MODEL 61

NEW CYLINDER AND PISTON

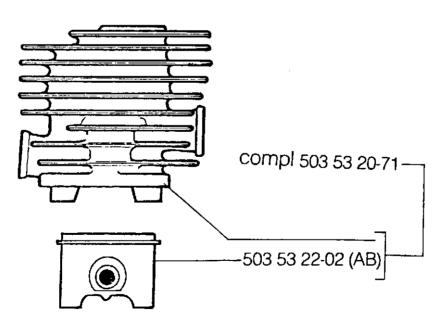
In order to improve the durability, a new cylinder and piston are introduced. At the same time, the "three class system" is excluded on the spare part piston compl. and changed to "one class".

There is full interchangeabilit, between an old and a new piston.

The change is introduced from serial number 7350750.

New Ref. No.	Description	Excluded Ref. No.	Remark
503 53 20-71	Cylinder compl.	501 53 35-71	
503 53 22-02 (AB)	<pre>{ piston compl. A Piston compl. B Piston compl. C</pre>	501 51 09-02 501 51 09-03 501 51 09-04	Remain as spare parts during a transi- tion period.
